TRUCK, UTILITY, LIGHTWEIGHT, MC2 - LAND ROVER 110 4X4 CARGO

FITTING OF STRETCHER RETAINING CLAMPS

MODIFICATION INSTRUCTION

Figure 1 - Stretcher Clamp Mounting

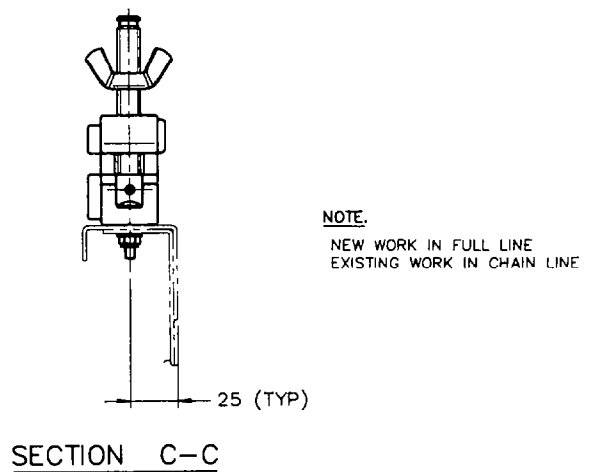
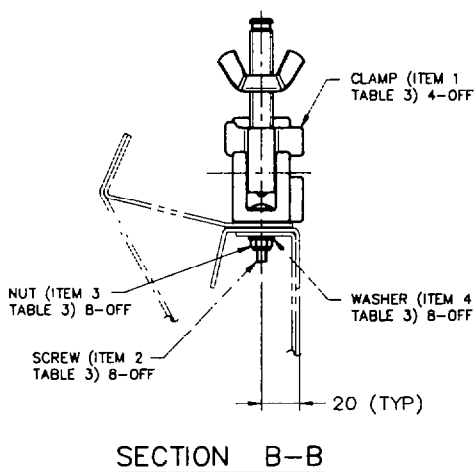
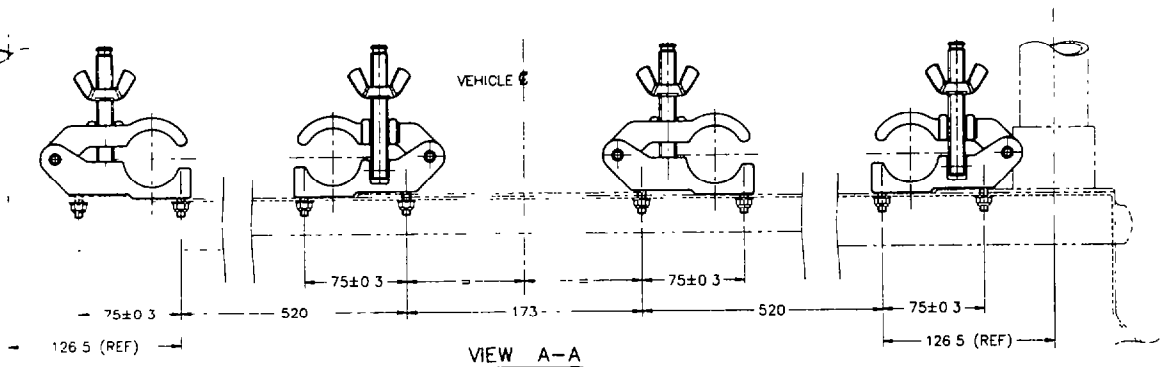
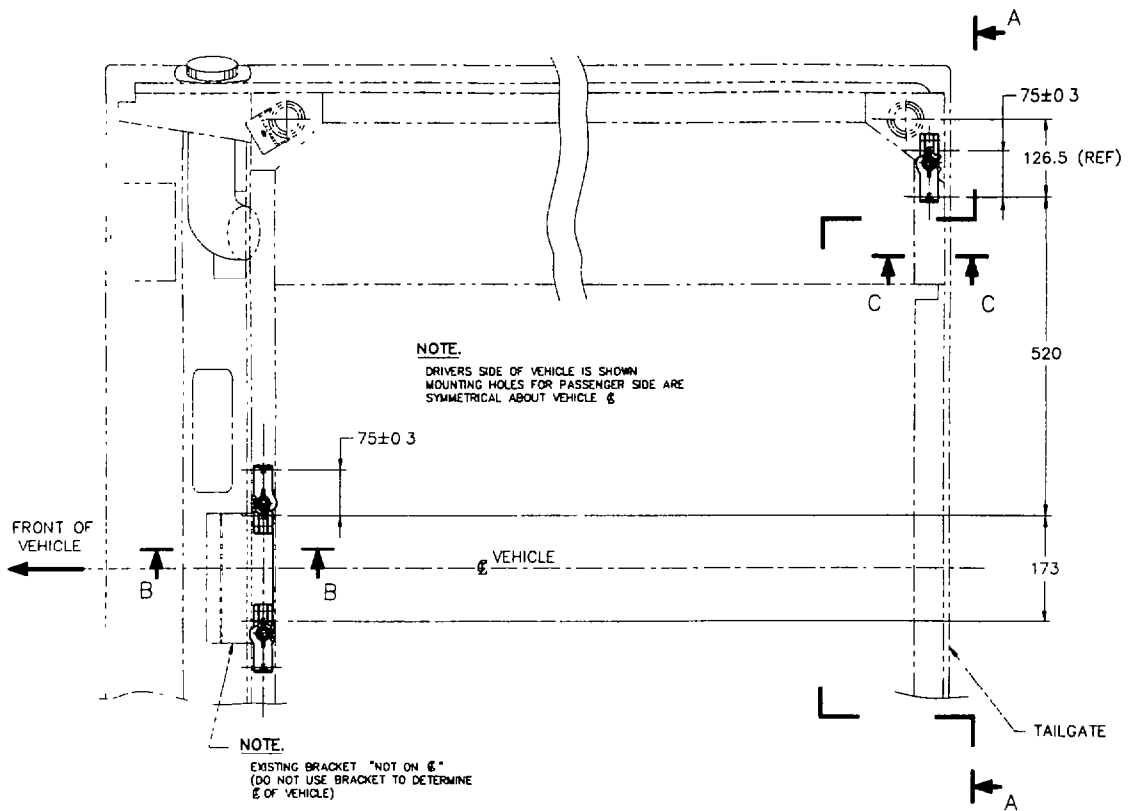
- a. Mark the centre line of the vehicle and the holes for the clamp mounting bolts on the front and rear bulkheads, as shown in Figure 1.

- b. Drill 7.0 mm holes for the clamp mounting bolts in the front and rear bulkheads, as shown in Figure 1.
- c. Remove or file flat the two outboard pop rivets fixing the Steyr barrel clip mounting bracket to the front bulkhead.
- d. Fit the clamps (item 1 from Table 3), using screws, nuts and washers (items 2, 3 and 4 from Table 3), so that the step in the clamp base mates with the step in the body metal.

The stretcher clamps are fitted to the front bulkhead with the hinge pins toward the center of the vehicle and on the rear bulkheads with the hinge pins toward the outside of the vehicle.

Figure 2 - Seat Base Mounting Holes

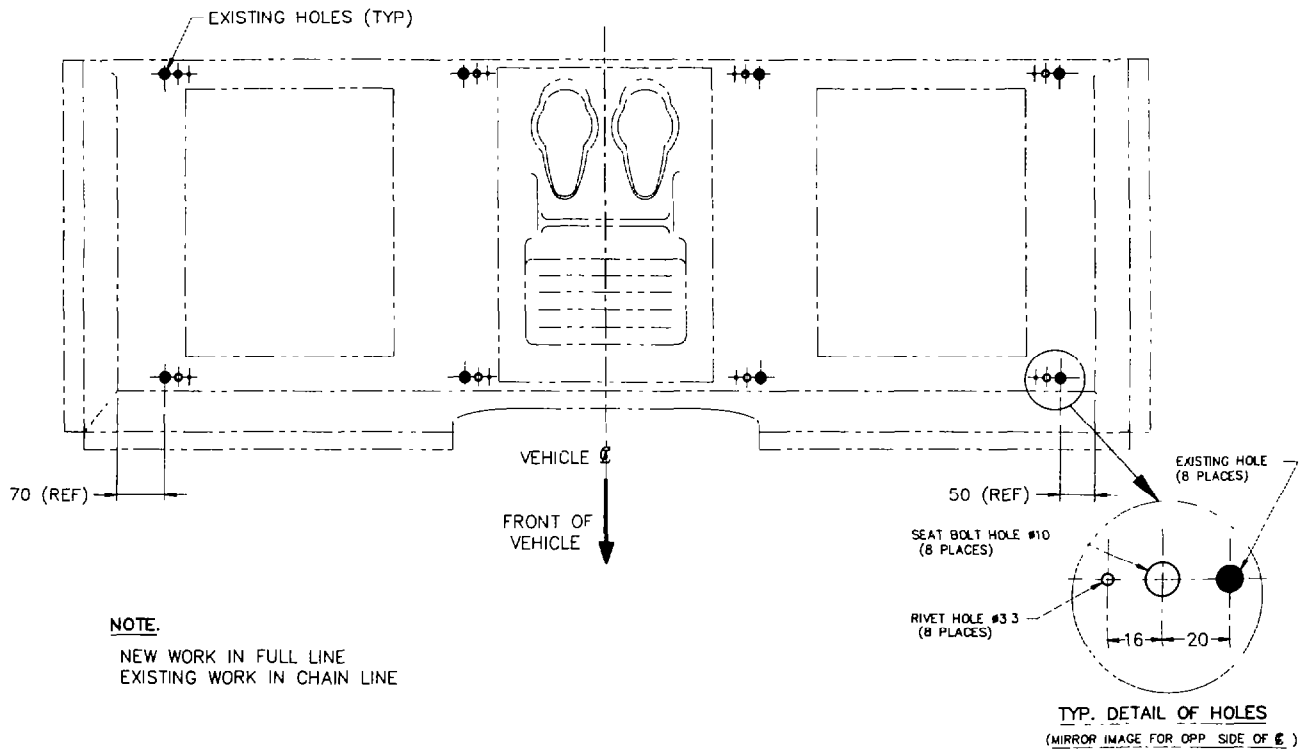
d. Mark and drill holes shown in Figure 2, as follows:

- (1) seat mounting bolt holes, 10 mm diameter hole, 20 mm inboard from the original holes, and
- (2) seat nut retention plate holes, 3.3 mm diameter hole, 16 mm inboard from the original holes.
